FEDERAL COMMUNICATIONS COMMISSION
445 TWELFTH STREET SW
WASHINGTON DC 20554

Re: WLUZ (FM), Levittown, PR
La Gigante Siembra
Facility Identification Number: 11520
Special Temporary Authority
BSTA-20130904ACH
Construction permit application
BPED-20130903AAZ

40 dBu interfering contour
 from BNPED-20071019 AZH

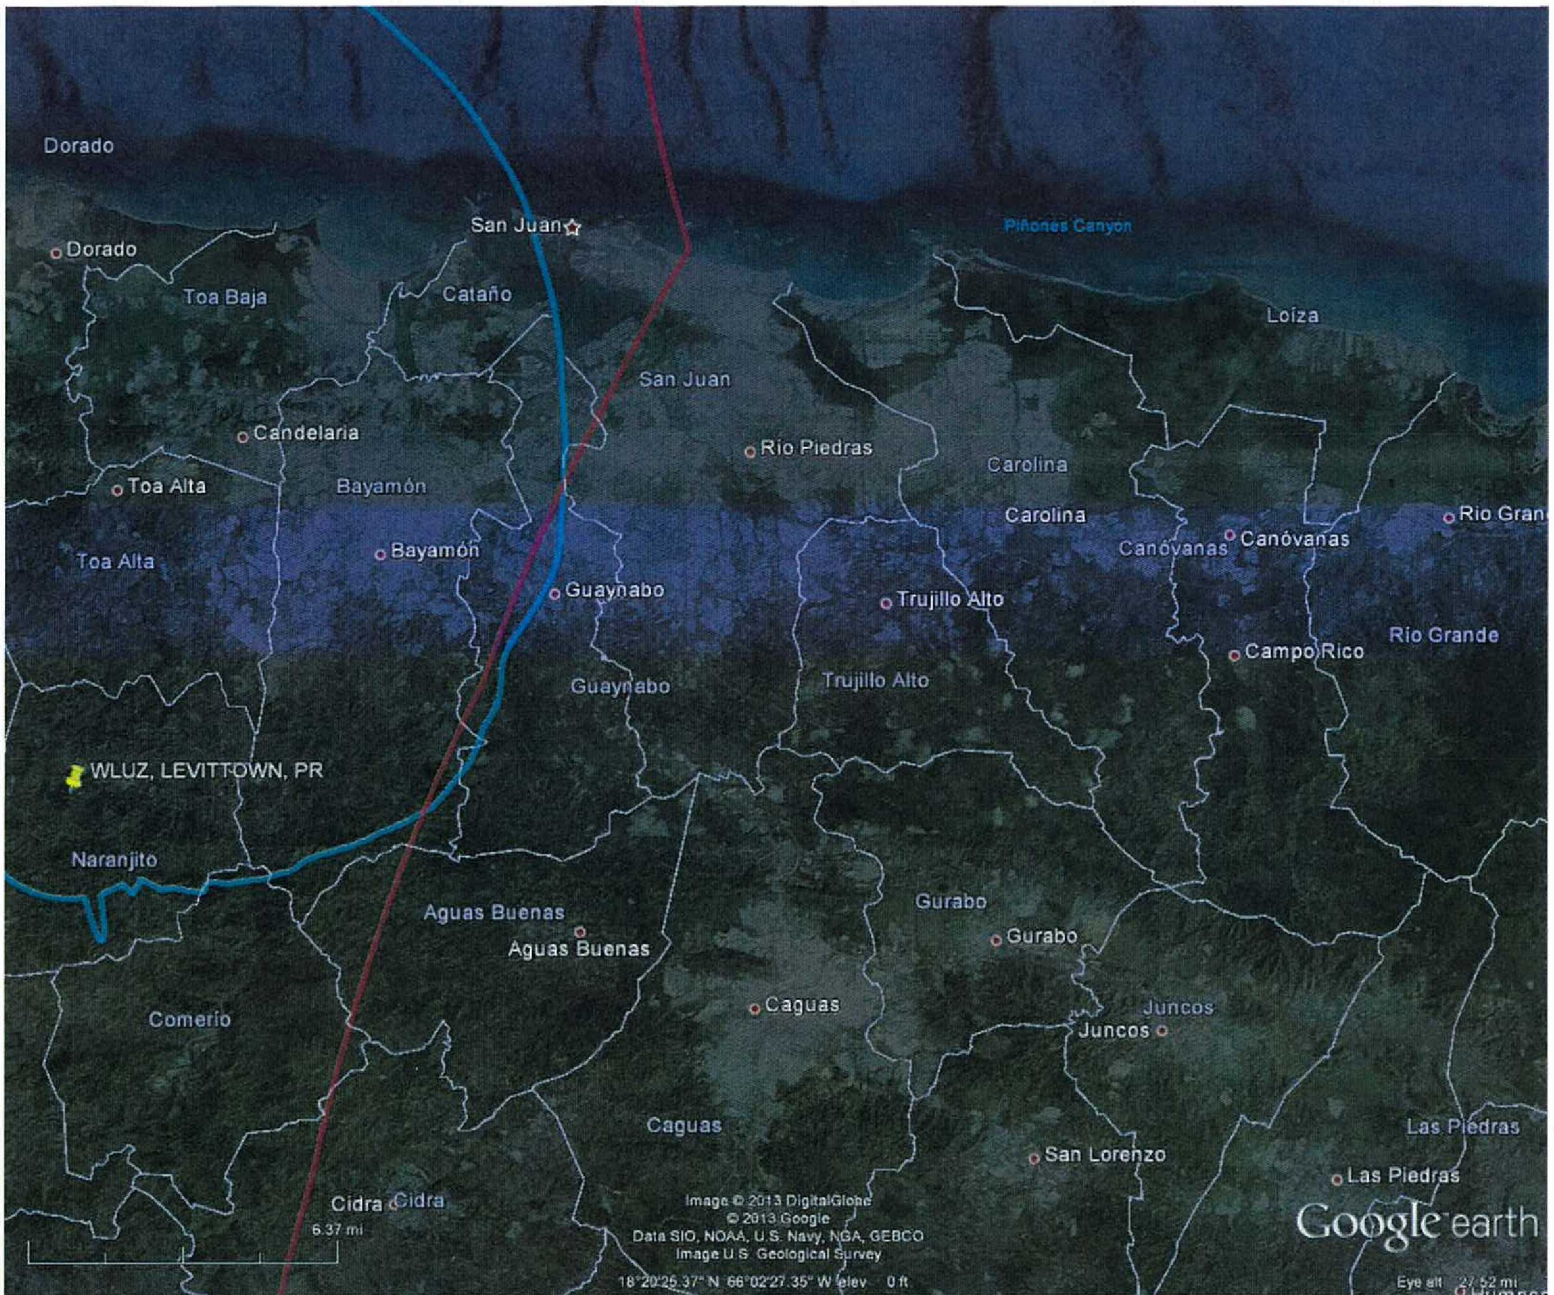
The construction permit application. As a construction permit application, the proposal also suffers from fatal deficiencies. We find that the applicant used the wrong protected and service contour values in conducting its analysis. Under Section 73.509, the protected service contour for noncommercial educational stations in the reserved portion of the FM band (Channels 201-220) is the 60 dBu F(50,50) contour, while the F(50,10) interfering contours are the 40 dBu (cochannel), 54 dBu (first-adjacent channel), and the 100 dBu (second and third adjacent channels). Using the correct contours, we find that prohibited contour overlap will exist between the proposed 60 dBu service contour for WLUZ and the 40 dBu interfering contour of the pending application for a new station at Viques, application file no. BNPED-20071019AZH (see attachment).³ Therefore the proposal is unacceptable for filing.

³ It appears that the applicant relied upon the alternate contours for Puerto Rico and the Virgin Islands in Section 73.215(a)(4), however, those contours are only applicable to FM commercial stations, and those relatively few FM noncommercial educational stations on Channels 218, 219, and 220 that are protecting commercial FM stations. All noncommercial educational stations on Channels 201 to 220 remain governed by the provisions of Section 73.509, NOT Section 73.215.

Given the circumstances, we are willing to expedite consideration of a new minor change application that corrects the listed deficiencies.
